# CENTRAL 70 PROJECT

Public Disclosure Administrative and Technical Proposal:  
5280 CONNECTORS

VOLUME 2 | Electronic Copy | Binder 8 of 8

<b>2.2</b>	<b>Alternative Technical Concepts (ATCs)</b>	
2.2.1	ATC 2.3 Colorado Interchange DDI .....	Binder 8
2.2.2	ATC 4.2 Storm Sewer Diversion.....	Binder 8

**Figure 1 – WB-67 Truck Turning Movement into “Eagle Claw” Property**

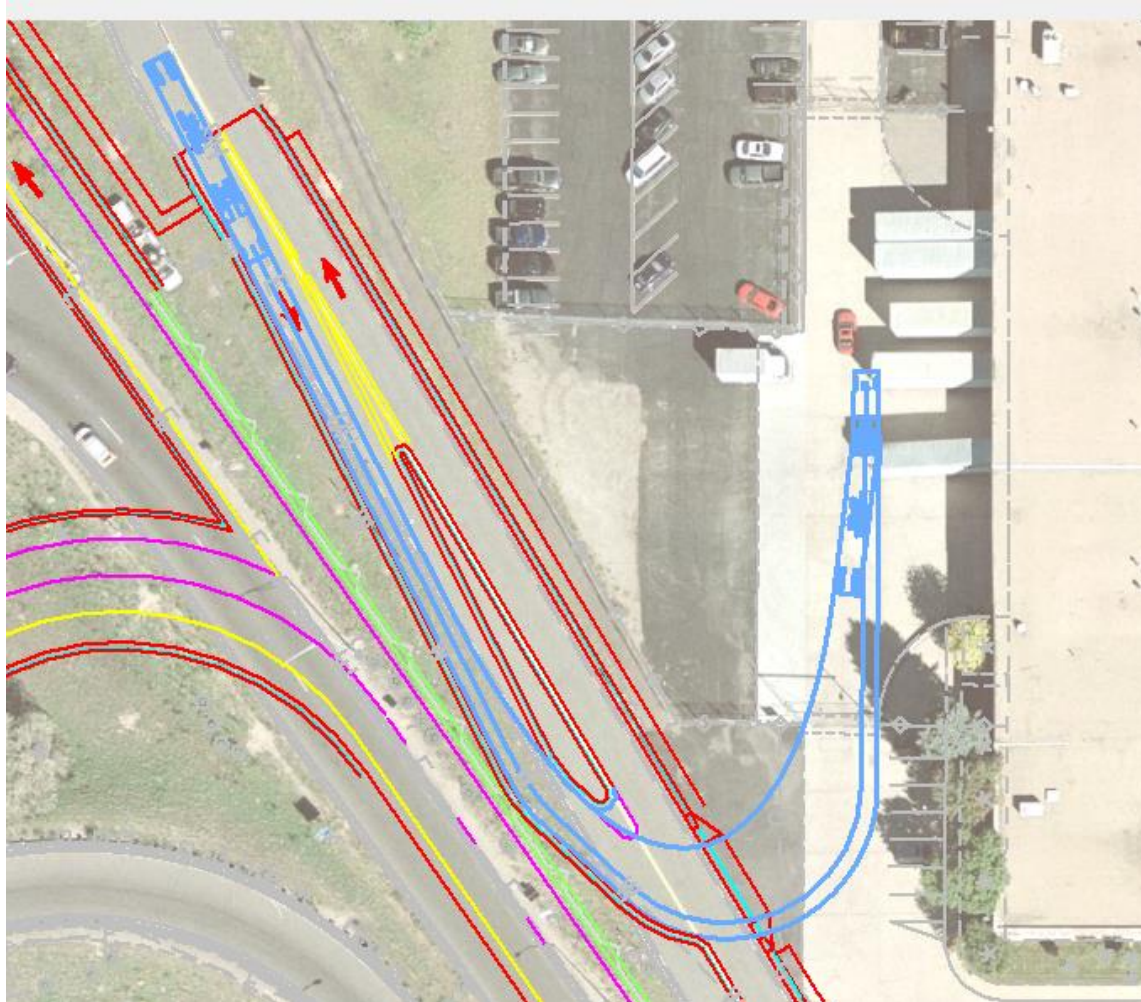
The RFP roadway plans shows some “tea-cup handle” geometry for the East 46<sup>th</sup> Ave southbound to eastbound movement so that vehicles heading to the “Eagle Claw” property can enter the property from the southwest corner of the property before the Local Access Road turns into a one-way westbound to northbound movement.

The ATC roadway plans provide similar geometry for this movement, allowing for a WB-67 (AASHTO 2011) to enter the property. The WB-67 can still maneuver through the existing gate in the southwest corner.

- 1) The RFP geometry provides for the access into the “Eagle Claw” property and can be modified slightly to allow for WB-67 turnaround movements from southbound to northbound along East 46<sup>th</sup> Ave.
  - a. The ATC “tea-cup handle” geometry design does not allow for a WB-67 turnaround movement. The ATC allows for a SU40 turnaround movement as long as the movement can encroach onto the “Eagle Claw” property to make this movement.

I-70 EAST ATC 2.2	
DDI AT COLORADO BLVD	
Designer:	Structure
Detailer:	Numbers
Sheet Subset:	Subset Sheets: of

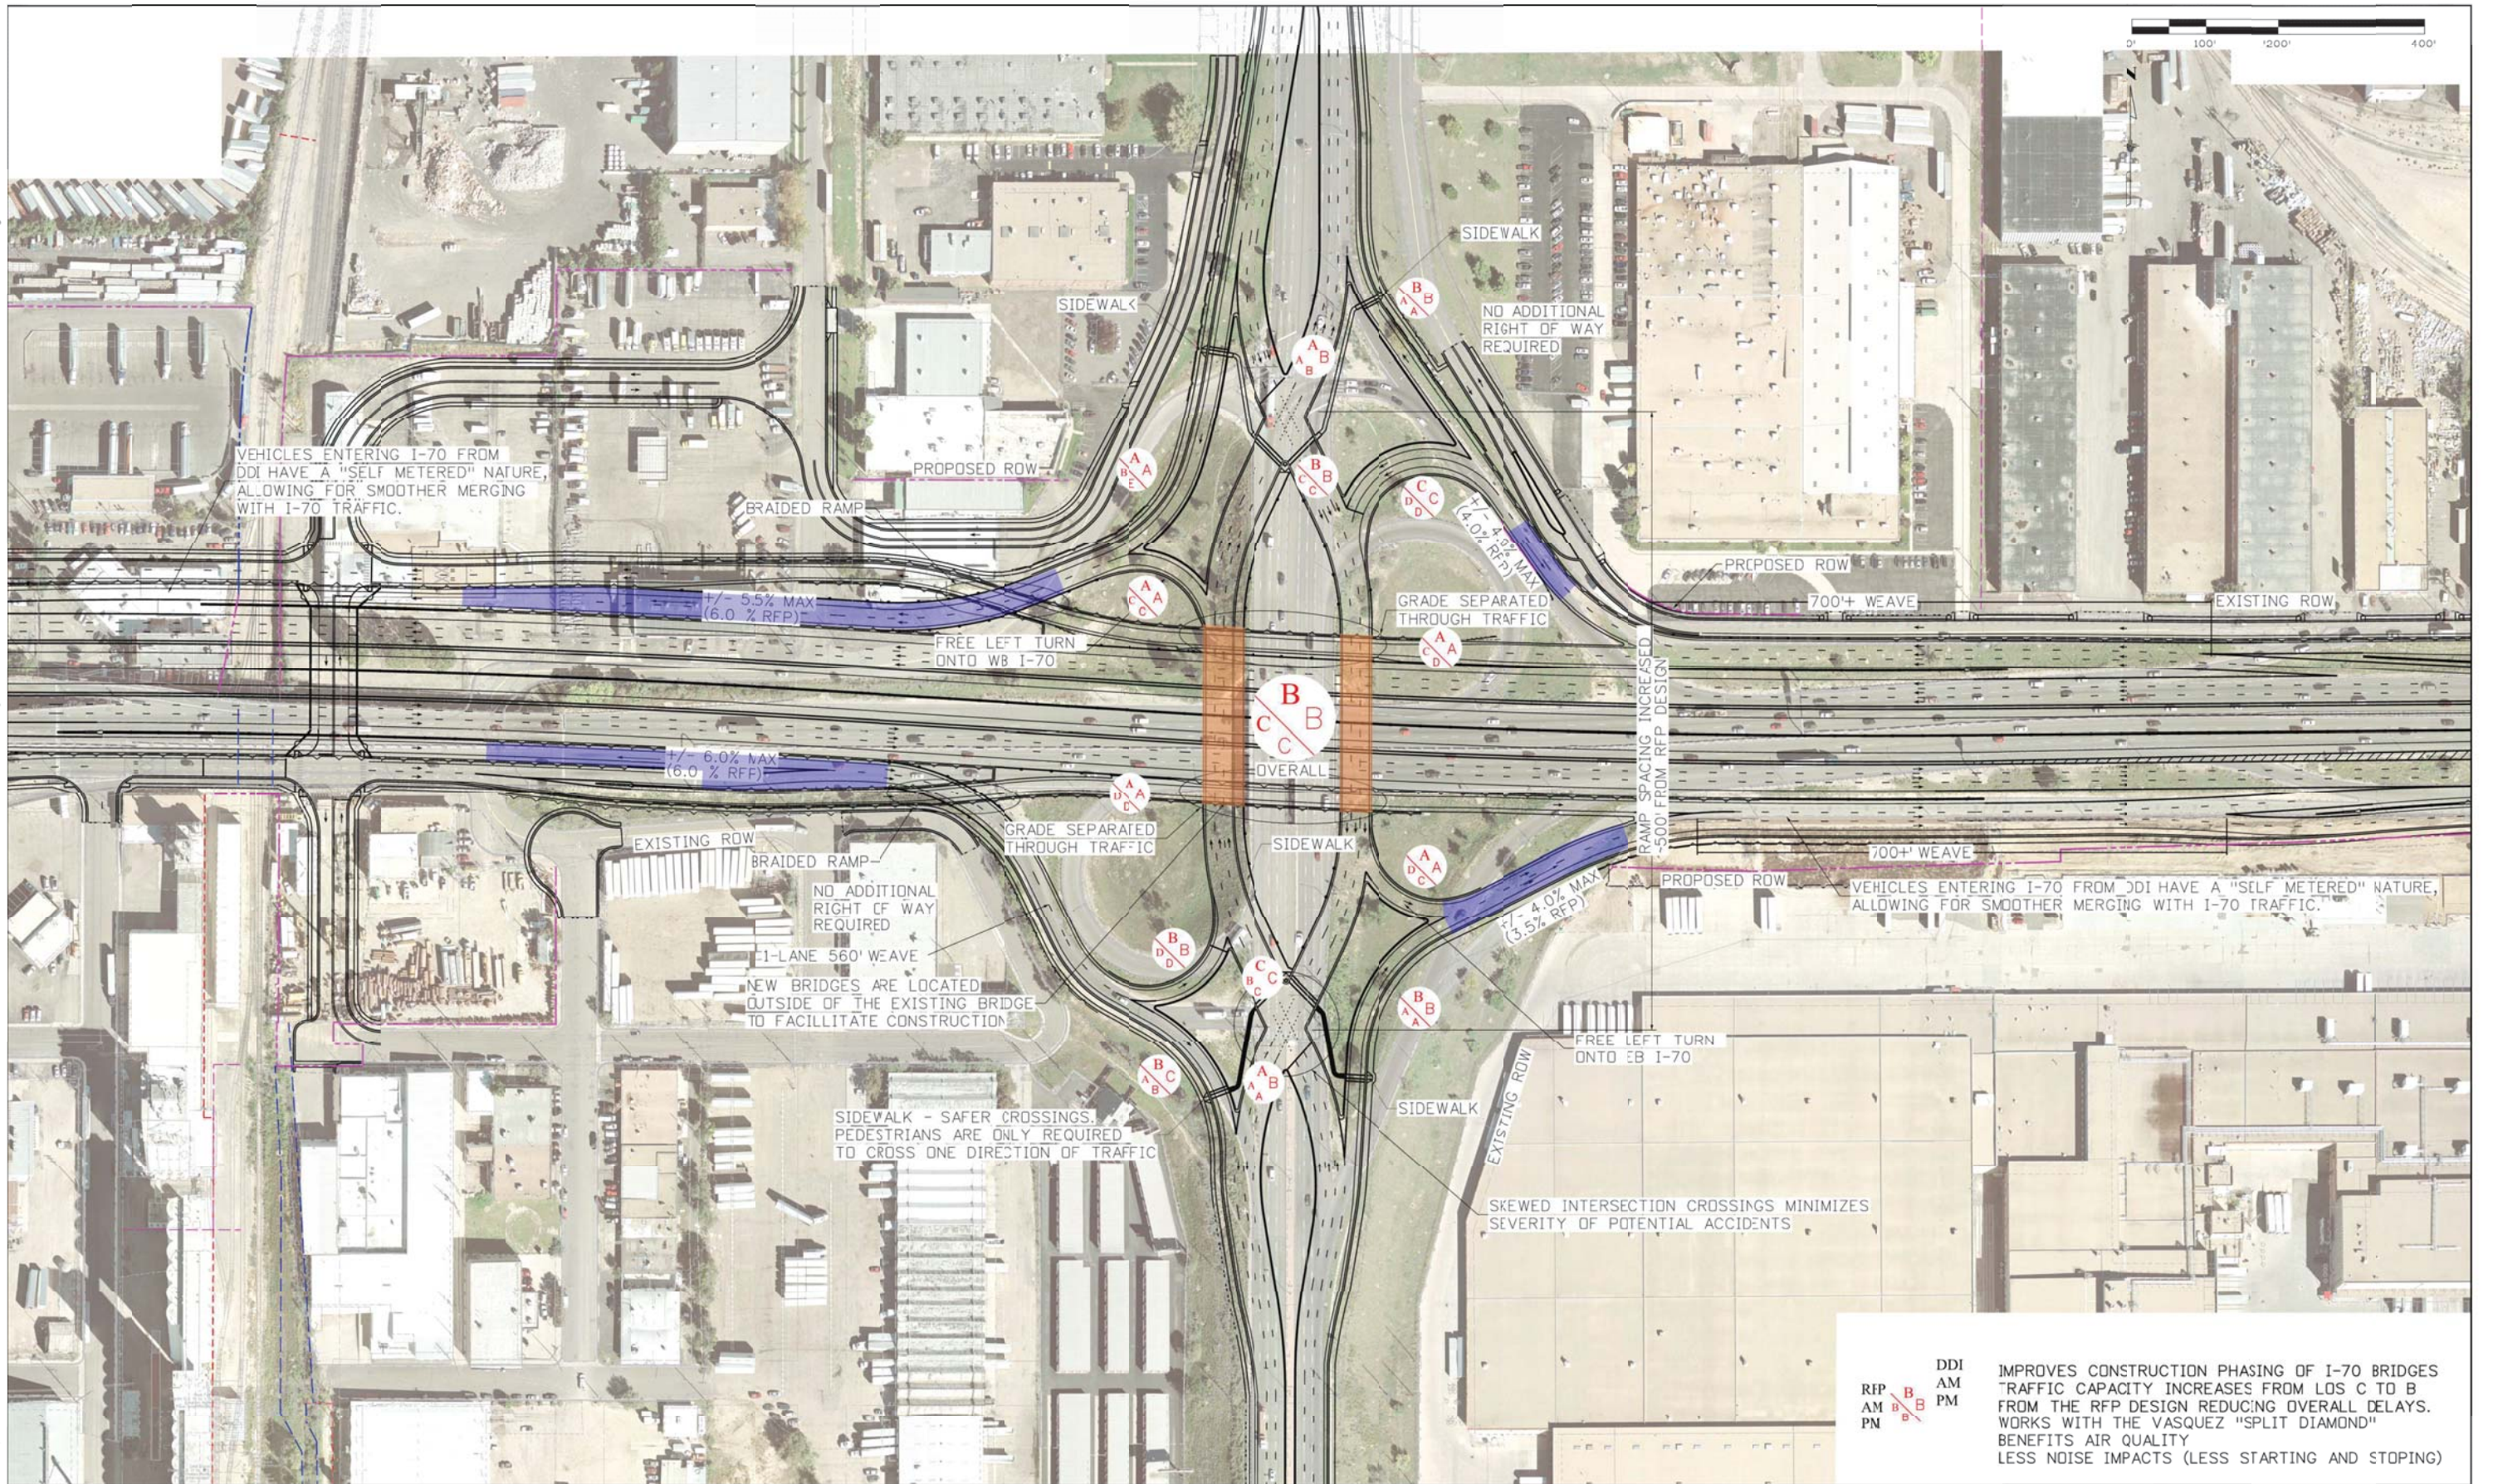
5280 Connectors proposes to replace the Colorado Boulevard “tight diamond” interchange shown in the draft RFP design with a Diverging Diamond Interchange (DDI).

- Grades within the interchange proper are less than 3%. (See Exhibit 1). This will provide for an improved vertical geometry in setting up curb ramps, and pedestrian pathways with less than 5% grades (See Exhibit 2).

**Figure 3 – Rerouted Movements for ATC DDI Design**

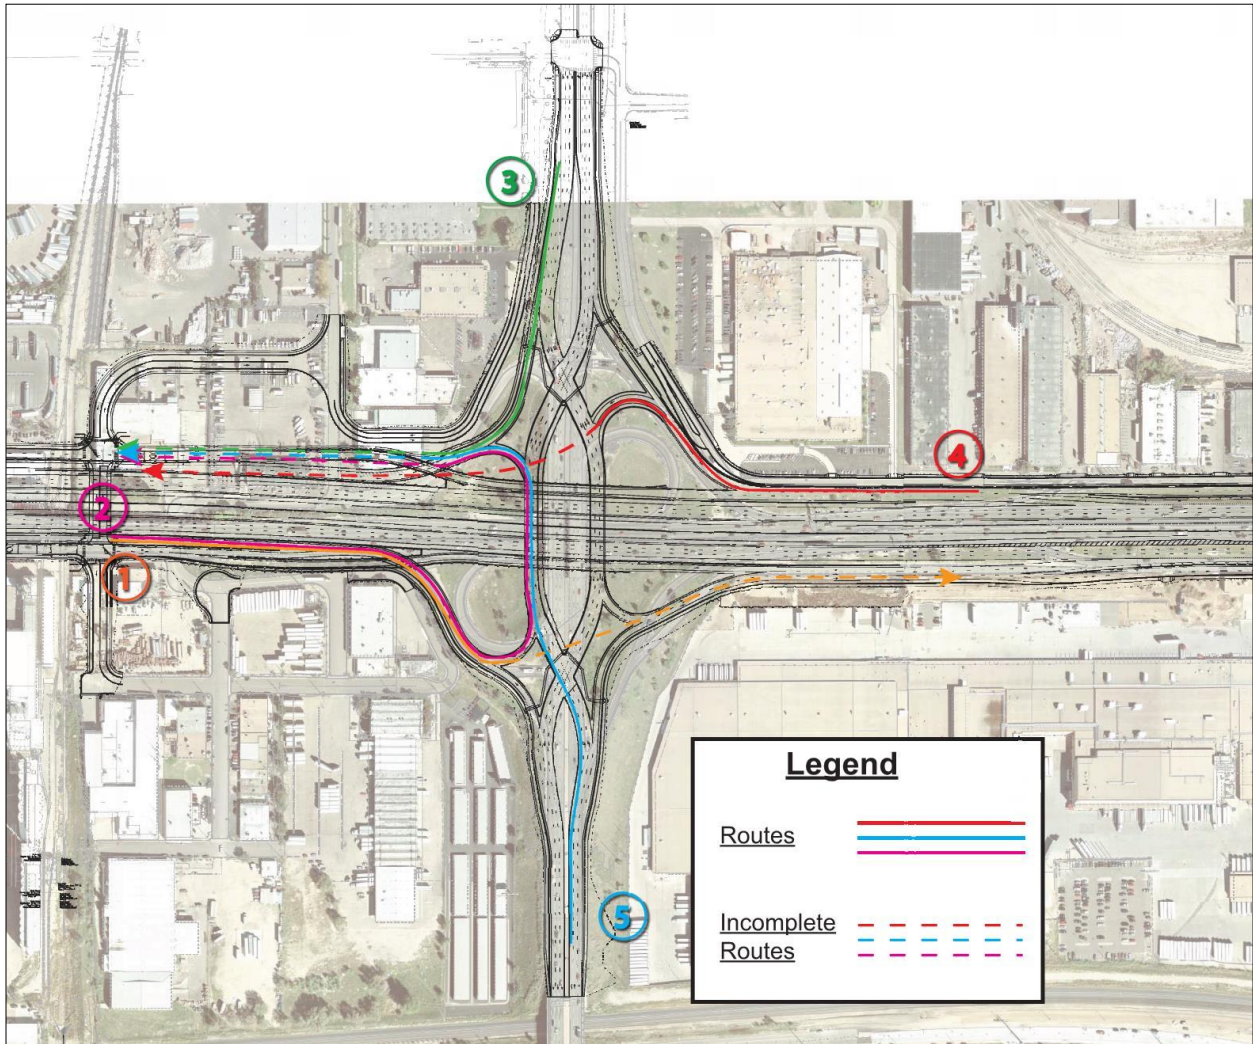
As previously discussed, the ATC design has access limitations due to the unique geometry of the DDI. Several movements that are allowed in the Baseline RFP will need to be rerouted in the ATC design. In total, there are five movements that are rerouted in the ATC design as compared to the Baseline RFP design (see Figure 3 and Figure 4). These rerouted movements include the following:

I-70 EAST ATC 25.2  
EXHIBIT 1  
SITE PLAN

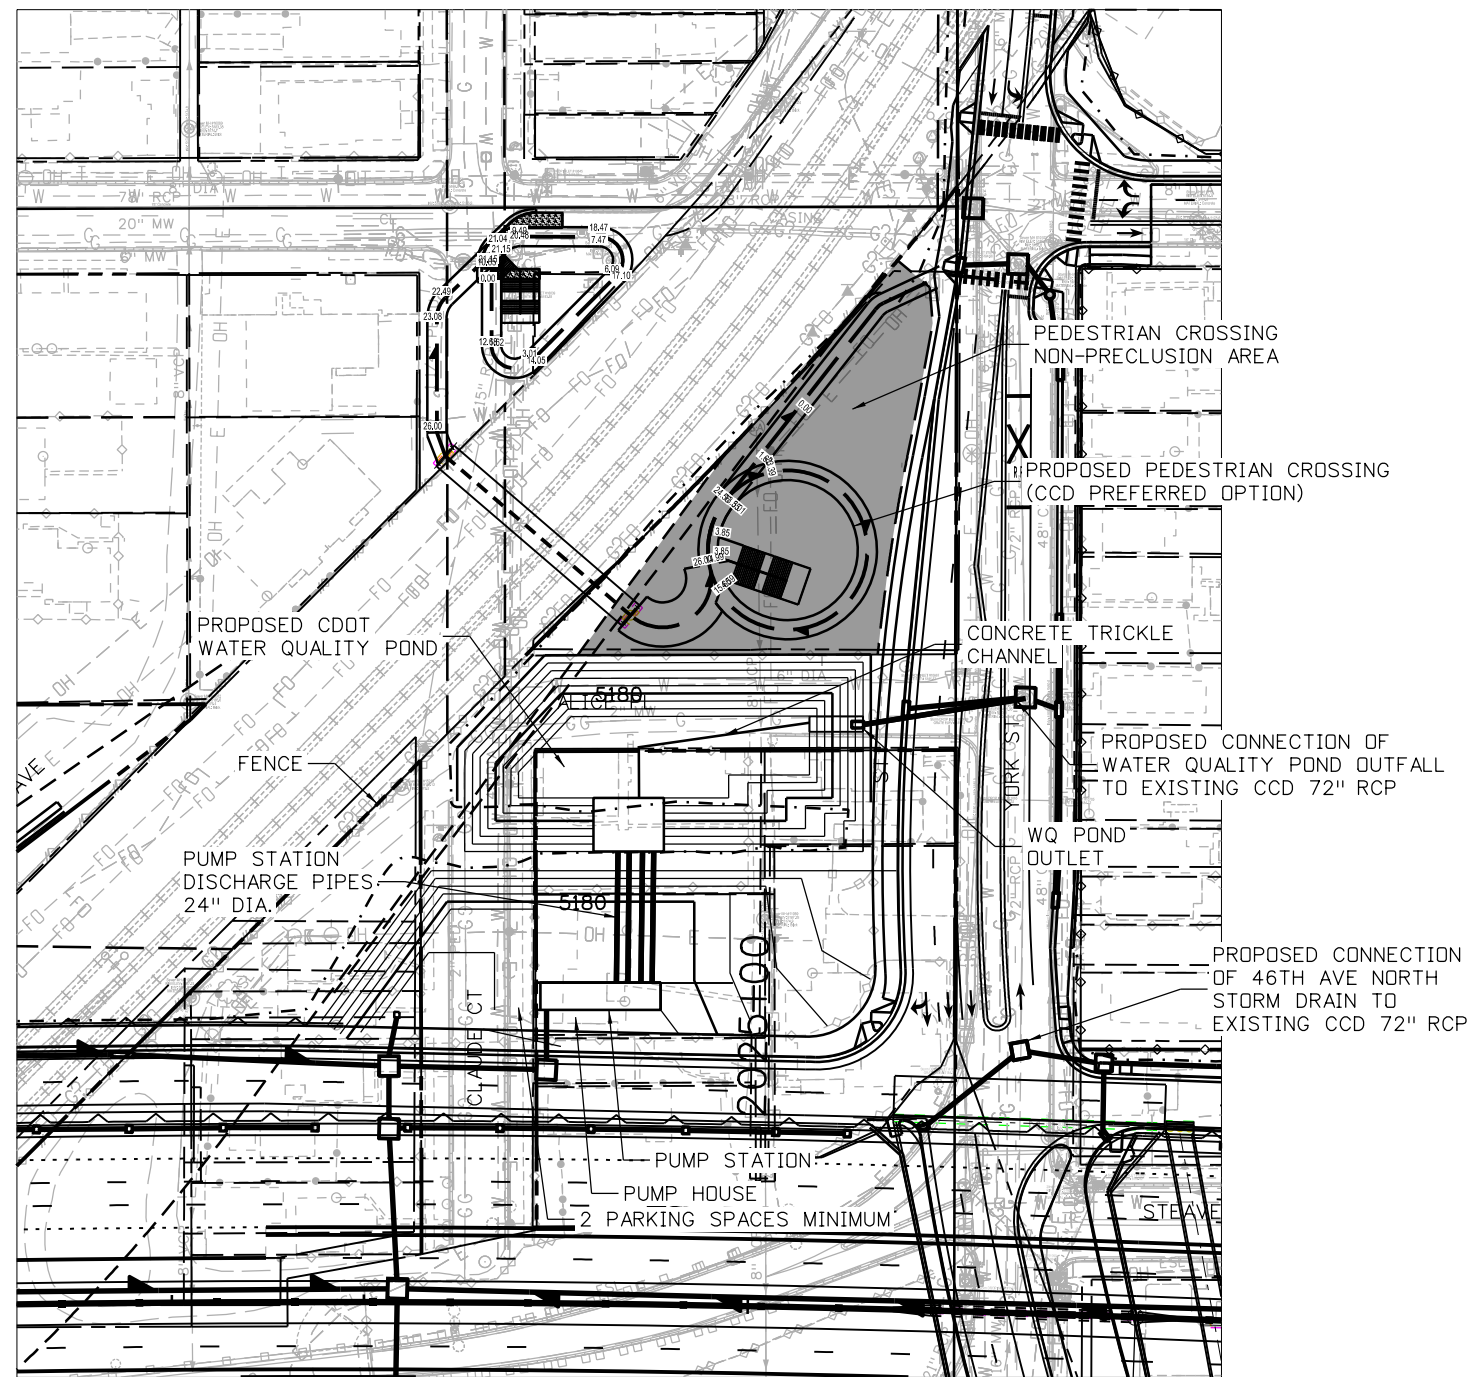
Exhibit 1 shows a preliminary site plan for the pump station and water quality pond that do not impact the future grade separation project.
